CORPS OF ENGINEERS DETROIT MI DETROIT DISTRICT
RECREATIONAL BOAT HARBOR, CEDAR RIVER, MICHIGAN. REVISIONS TO G--ETC(U)
AUG 80

1. REPORT NUMBER	2. GOVT ACCESSION NO. AD-A107091	3. RECIPIENT'S CATALOG NUMBER
4. TITLE (or Subtitle) Supplement no.1 revisions to General Design Memorandum no.1 and Environmental Impact Statement Recreational Boat Harbor Cedar River, Michigan.		5. TYPE OF REPORT & PERIOD COVERED Final Report

Recreational Boat Harbor, Cedar River, Michigan. Revisions to General Design Memorandum Number 1 and Environmental Impact Statement. Supplement Number 1.

PLAN

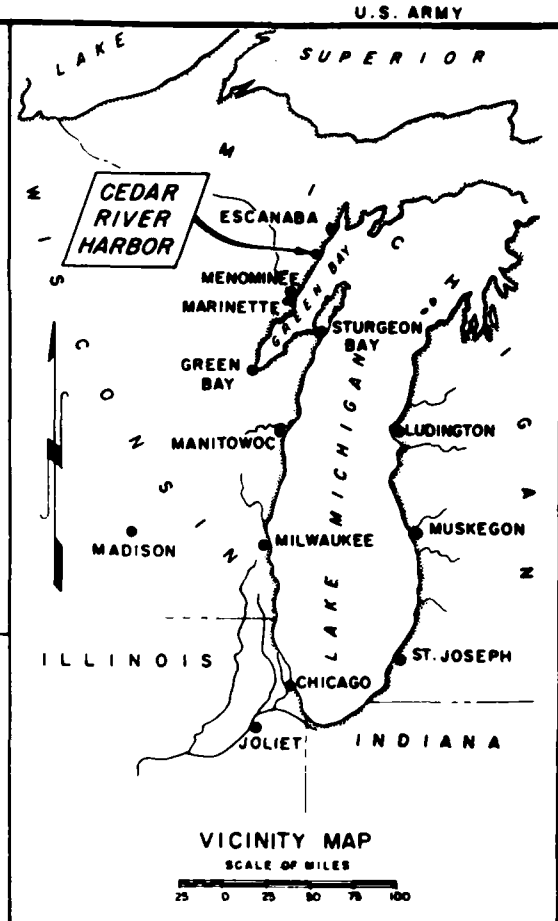
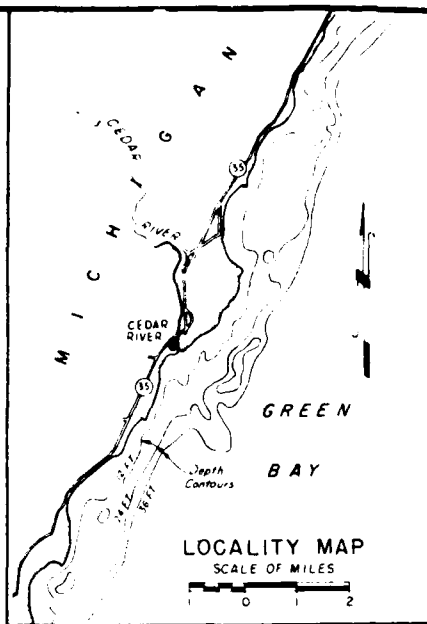
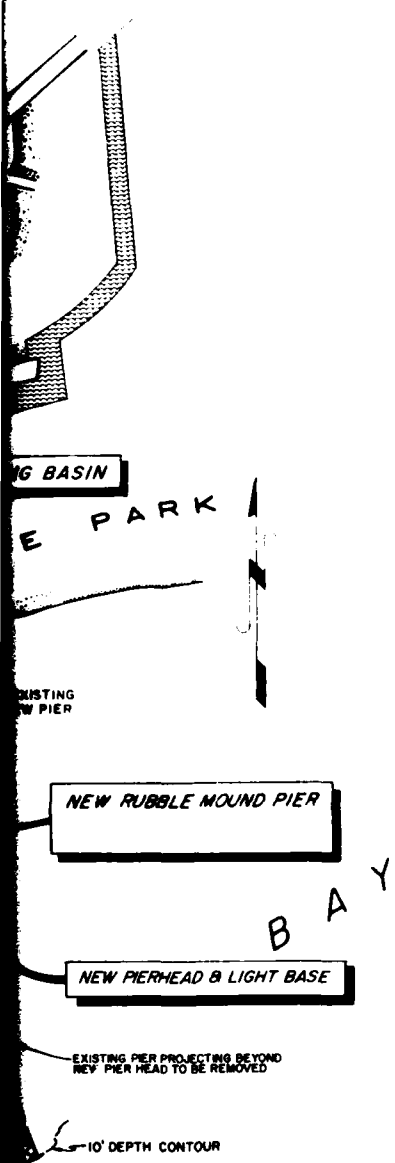
NEW RUBBLE MOUND

NEW PIERHEAD & LIGHT

EXISTING PIER PROJECTING BEYOND NEW PIER HEAD TO BE REMOVED

Figure 11a

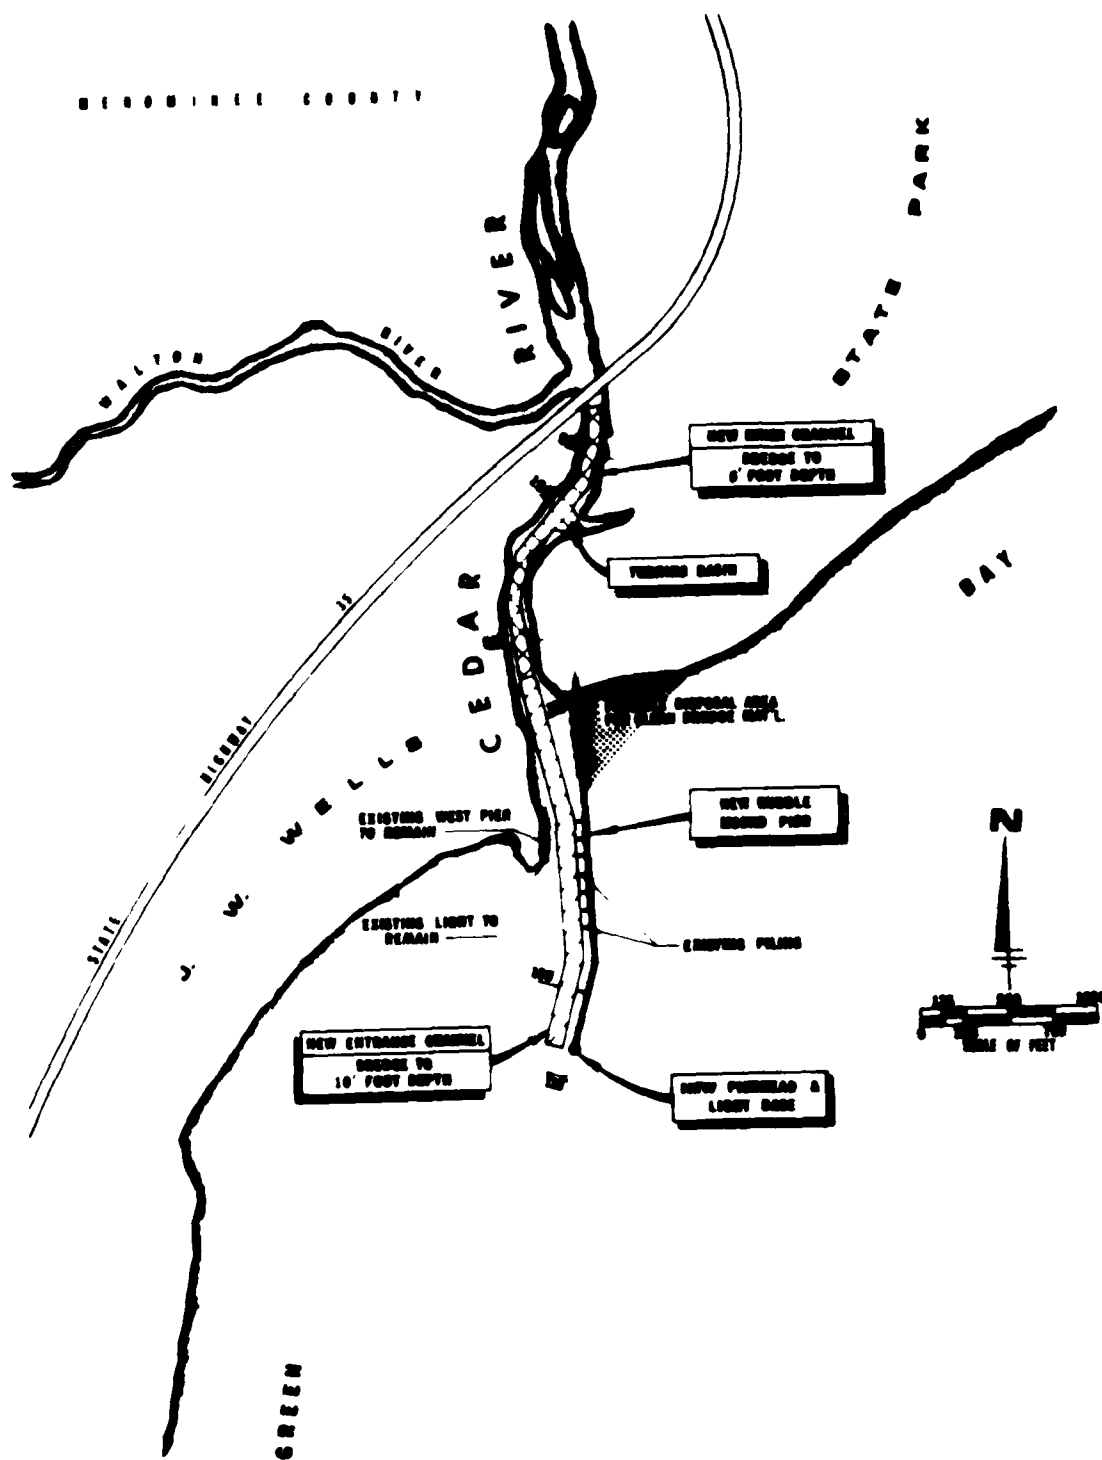
2.12 Alternative 1 is the construction of a 2,100 foot long rubblemound pier as authorized by the River and Harbor Act of 1965. Studies conducted since authorization of the original plan have shown that shore erosion could be minimized with a shorter pier design (Figure IIa).
